Subject: Duke Energy Corporation  
Catawba Nuclear Station, Unit 2  
Docket Number 50-414  
Response to Request for Additional Information for  
Unit 2 Reactor Coolant System Cold Leg Elbow Tap Flow  
Coefficients

**Attachment 1**  
**Response to NRC RAI Dated December 18, 2002**  
**and Followup Question From Telecon on January 16, 2003**

**Figure 1**  
**Analytic Model vs. Elbow Tap Flow Comparison, RCS Total Flow**

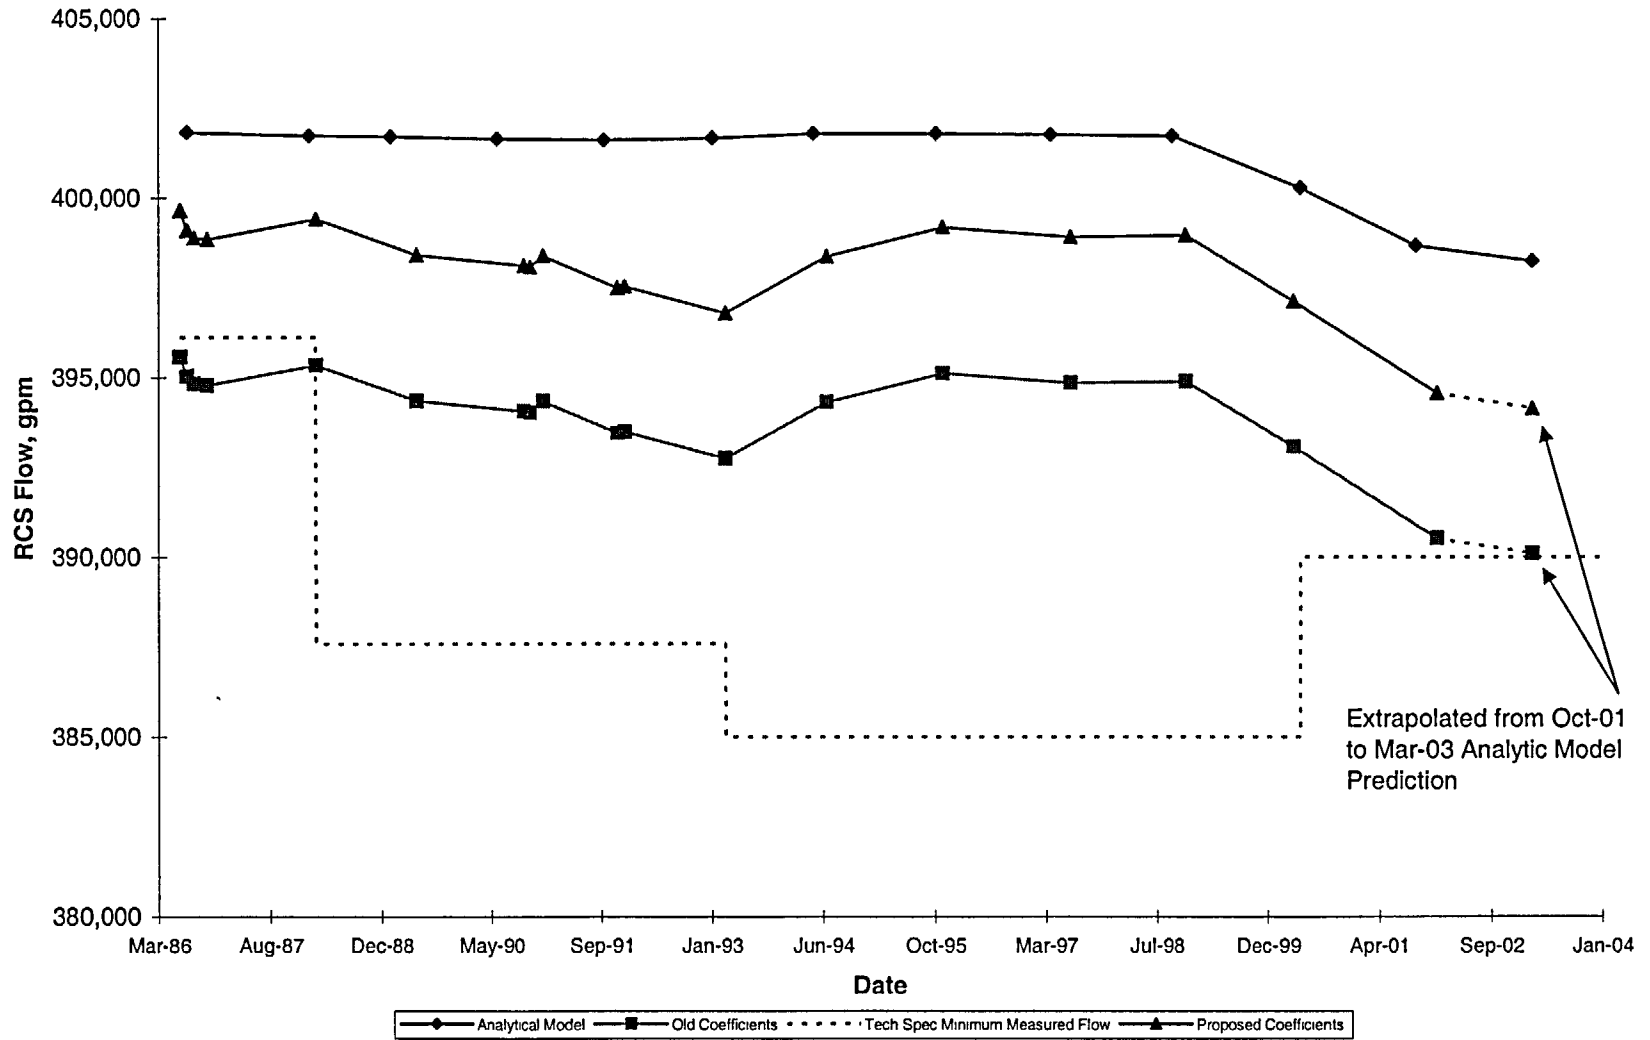
3. The Catawba Unit 2 total flowrate (Refer to Figure 1) as indicated by the elbow tap instrumentation indicates a decrease in flow in the October 1991 and the February 1993 data, followed by an increase in flow. Explain this data trend relative to the flow prediction of the analytical model, which shows no significant flow change, in particular relative to the possible effects of the core power distribution.

During the time period of the decrease in flow of concern, four types of potentially relevant design changes occurred in Catawba Unit 2. The response to Question #1 includes the steam generator tube plugging information and the Westinghouse OFA to FANP Mk-BW fuel assembly design transition information that occurred in this time period. Not included in the response to Question #1 was a decrease in the primary temperature program of  $-3.3^{\circ}\text{F}$  for the purposes of slowing the rate of steam generator tube corrosion. This occurred in November 1995. Also not included in the response to Question #1 was the change in the core loading pattern during each refueling outage. Both of these changes were considered to have minimal effect on the flow, and so they were not mentioned. Neither of these effects (primary loop temperature reduction or core power distribution) accounted for the changes in measured flow in 1991 and 1993 but is included in the discussion below for completeness of the historical flow trend review.

The  $-3.3^{\circ}\text{F}$  reduction in primary coolant temperature in 1995 would cause the following associated changes. Since the reactor coolant pumps are constant volume flowrate pumps, the volumetric flow would not change. The mass flowrate would increase due to the higher density following the temperature reduction. The effect on loop pressure drop would be insignificant due to a minimal change in fluid velocity. The flow data for the time at which this change was implemented, November 1995, shows a small increase in flow. This measurement also was affected by a small amount of steam generator tube plugging (flow decrease) and the third and final cycle of the fuel transition to FANP Mk-BW fuel (flow increase). The analytical model predicted no change in flow between 1994 and 1995. Duke's interpretation is that the change in measured flow is small and is due to process measurement drift and expected variation in flow.

Duke has analyzed Cycles 6 and 7, which are the most different relative to the core power distribution, with the VIPRE-01 code to calculate the core pressure drop. A one-eighth core VIPRE model with one channel per fuel assembly was used. The results of this analysis shows that there was no difference in the core pressure drop to the second decimal point. This was expected since there is no bulk boiling in the core. To confirm that this VIPRE model is capable of calculating a change in core pressure drop due to a change in power distribution, the same model was run with an arbitrary increase in the peaking factor in one fuel assembly (8 fuel assemblies out of 193 in full core). The peaking factor was increased from 1.2 to 1.8 to obtain a channel exit void fraction of 2%. With this unrealistic increase in the power distribution the core pressure drop increased by 0.03 psi. Such a change in core pressure drop will cause no measurable change in loop flow. These results support a conclusion that the core power distribution changes in Catawba Unit 2 during the time period of interest are not associated with the indicated flow trend.

The plant elbow tap flow instrumentation maintenance history is being reviewed for the time period of interest. Should this review identify any contributing causes to the indicated flow trend, that information will be forwarded to the staff. The known design changes cannot account for the observed trend, and no other explanations have been identified.

**Figure 2**  
**Analytic Model vs. Elbow Tap Flow Comparison, Loop A**

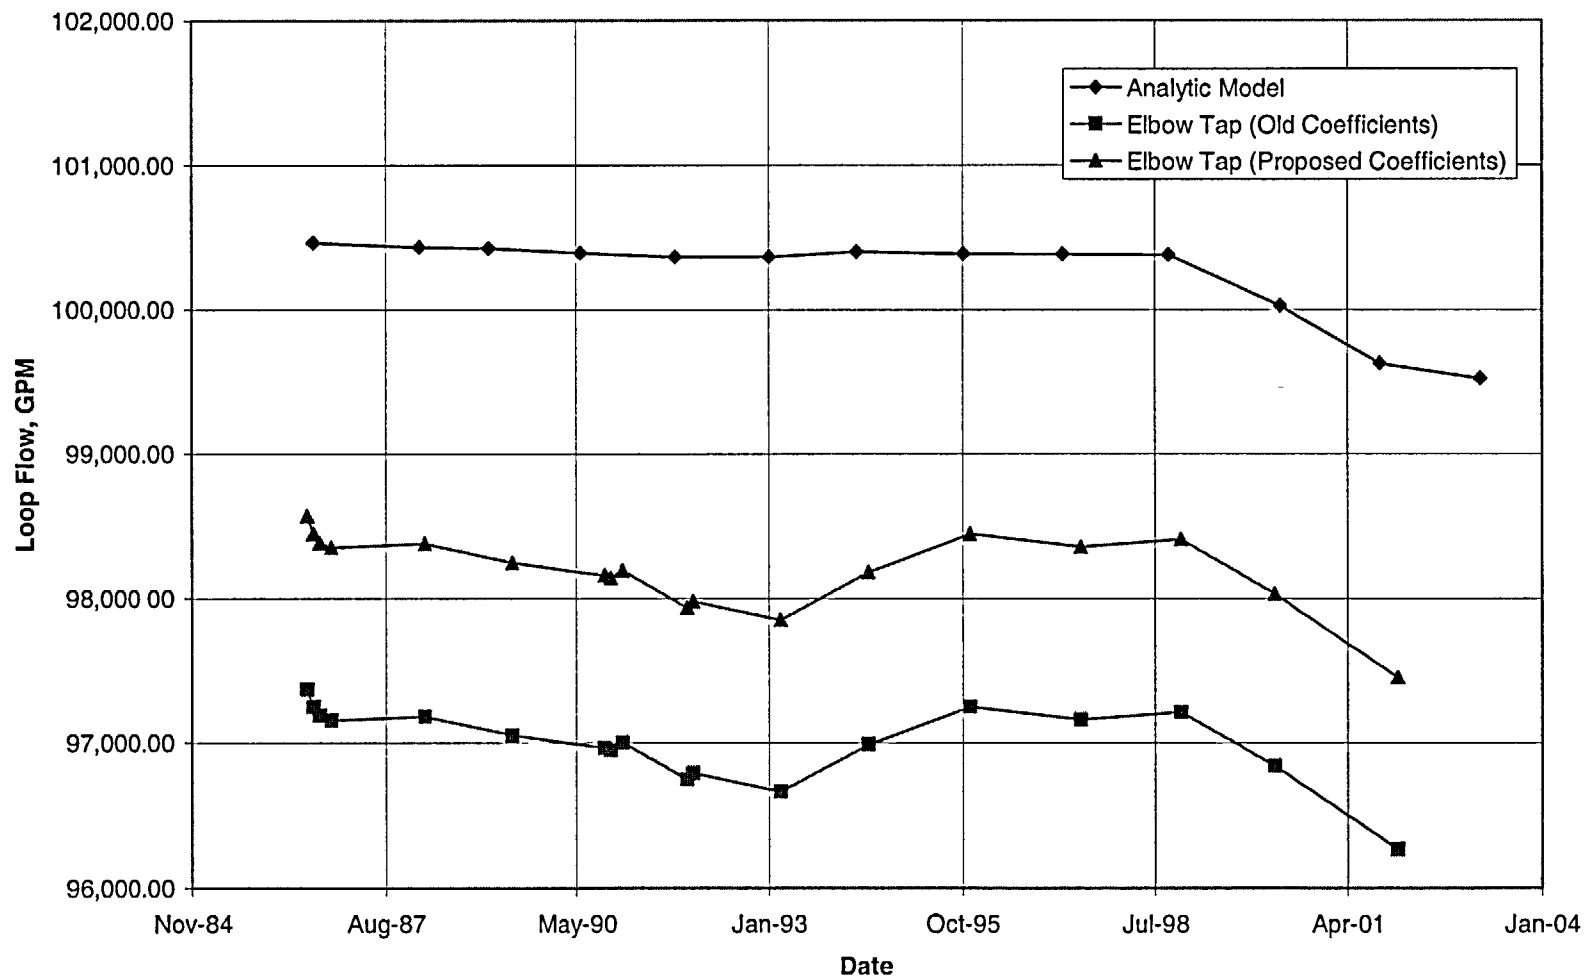
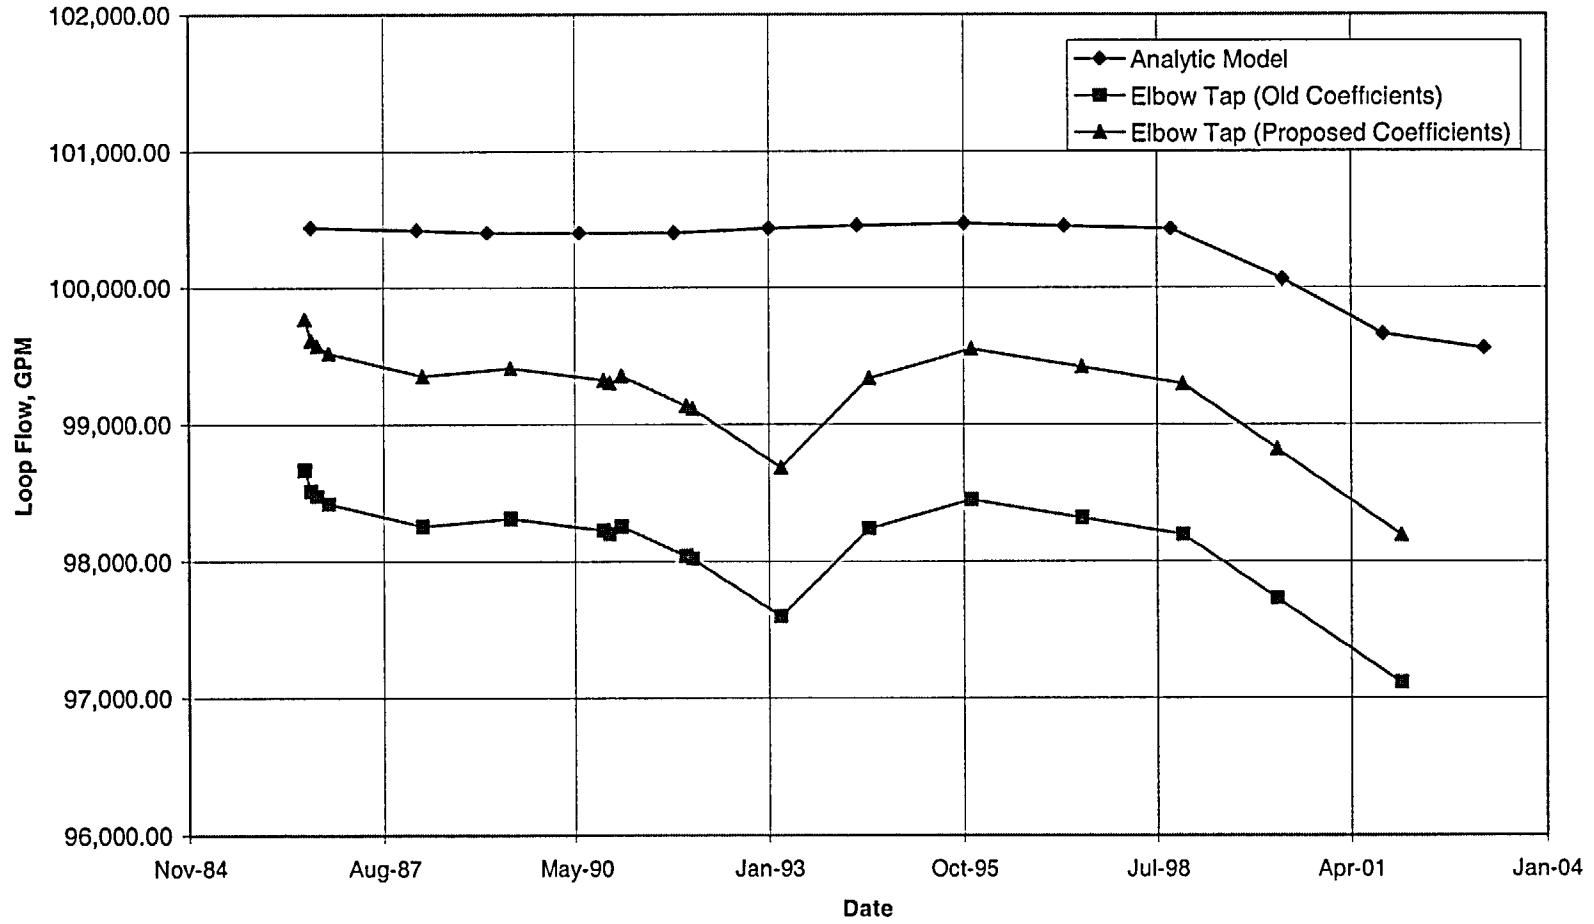
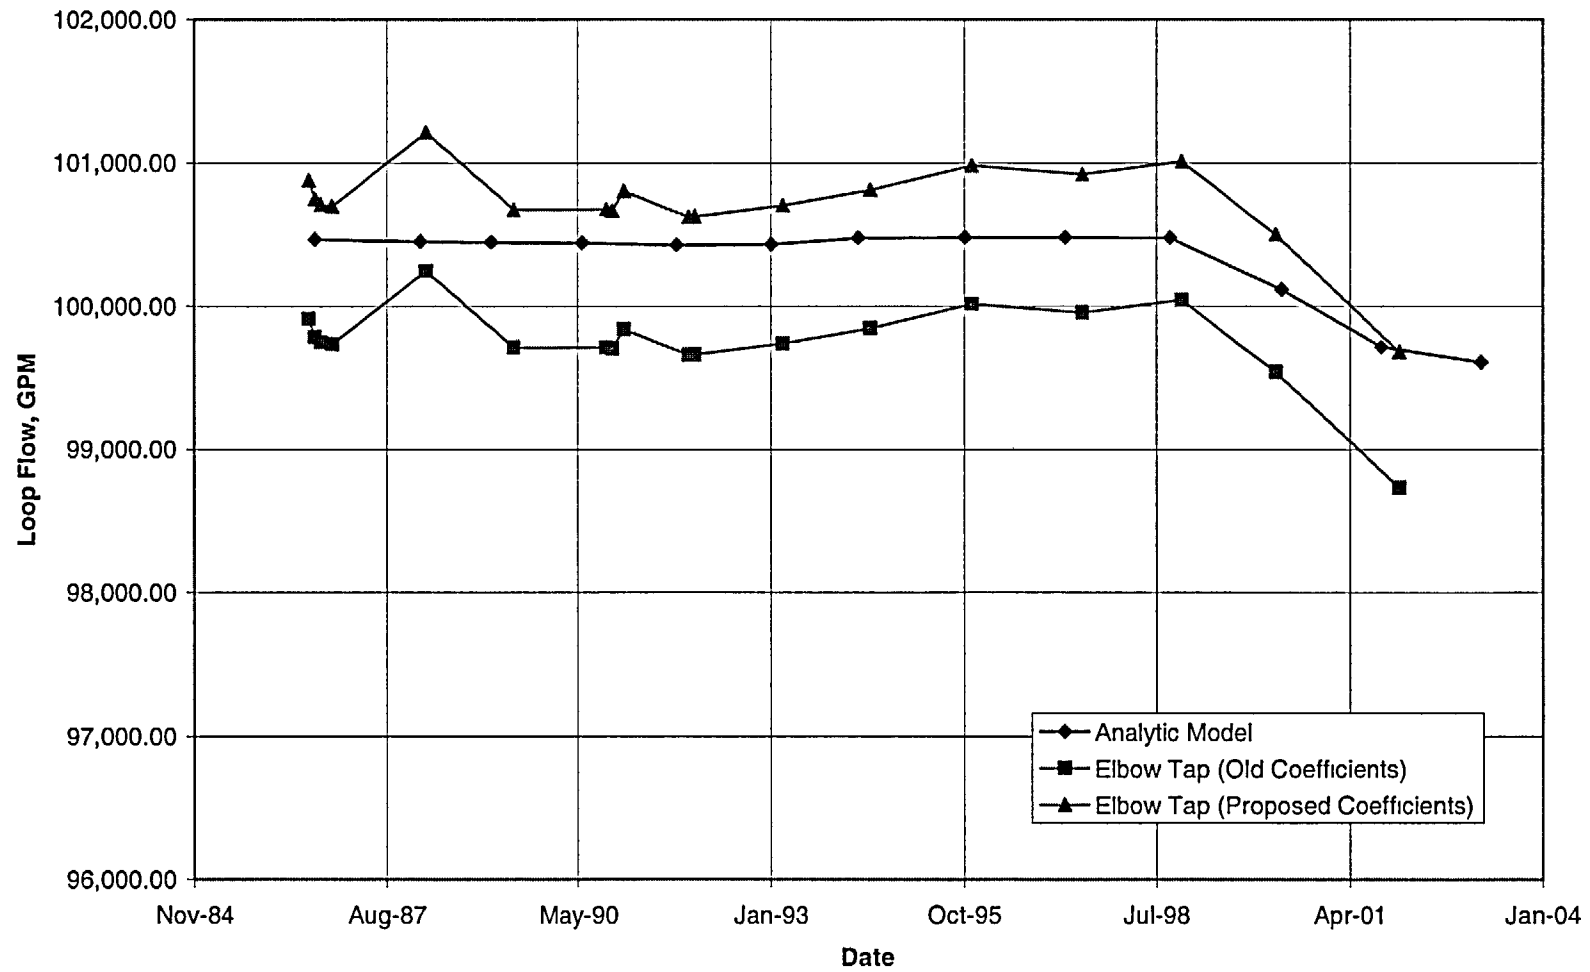
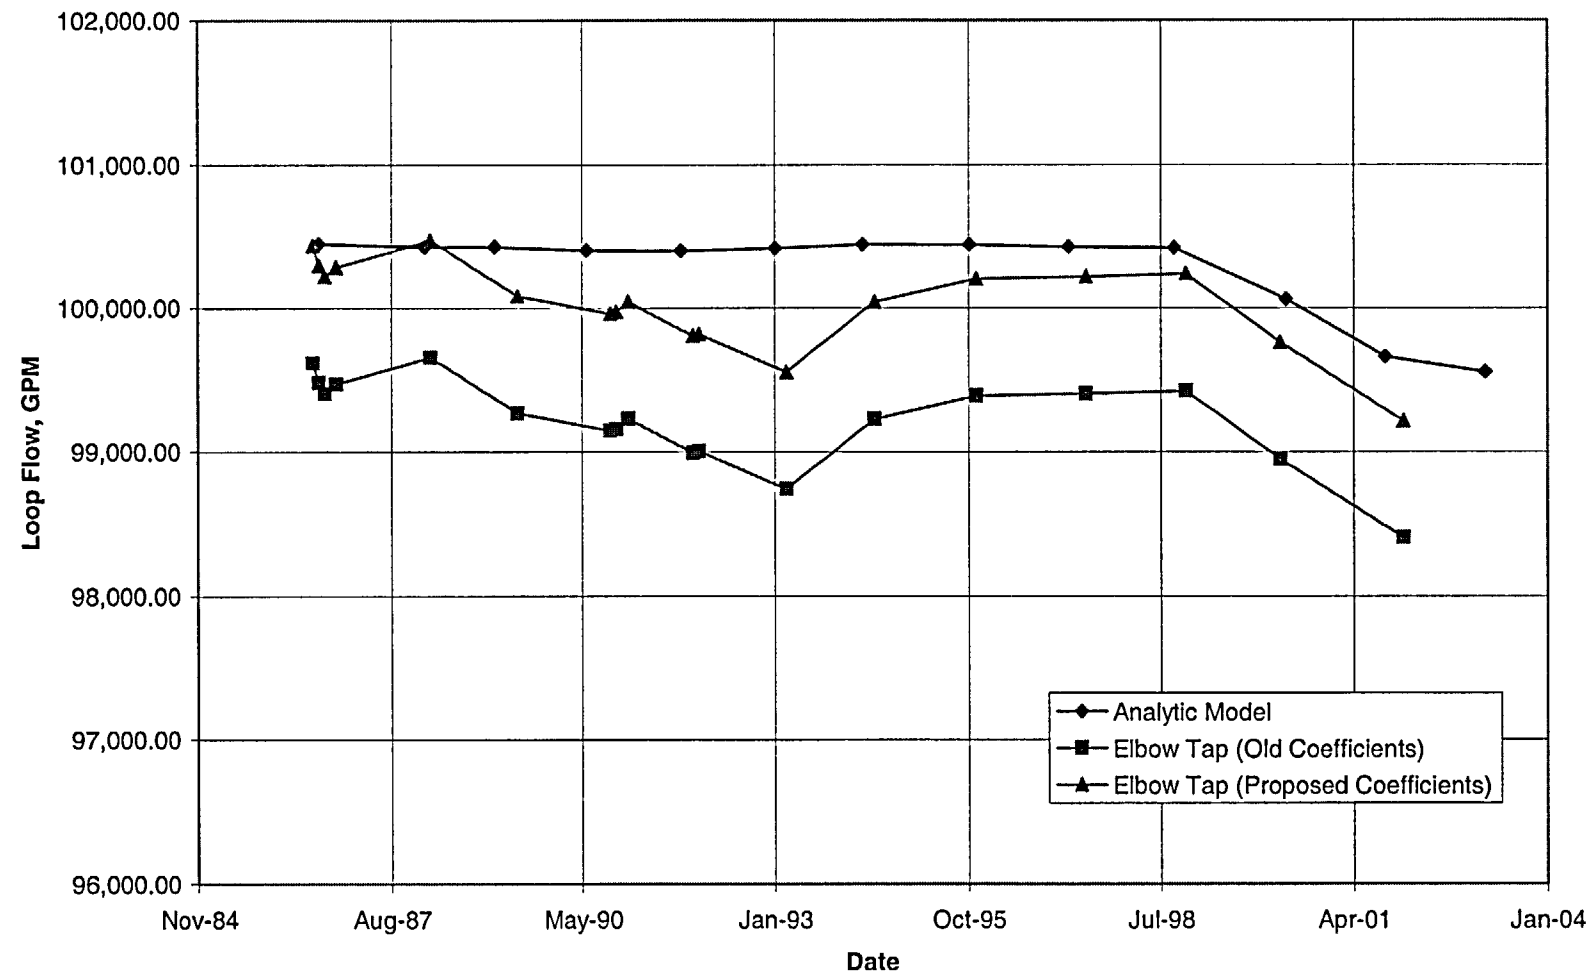
- a. A complete copy of your analytical model, and
  - b. A comparison of predicted RCS flow rate in each of the four loops and flow rate determined by the elbow taps with the assumption of constant flow coefficients for past configuration changes such as changes in fuel configuration, SG tube plugging, and reactor coolant pump replacements (if any). The basis for the assumed impact of each configuration change as an input to the analytical model should be described.

Figure 1 represents a comparison between the elbow tap flow indication of total RCS flow and the analytical model calculation of the total RCS flow. Two elbow tap indications of total RCS flow are given, one for the old elbow tap coefficients and one for the new proposed coefficients. Figures 2 through 5 contain a similar comparison between the individual loop flows and those calculated by the analytical model.
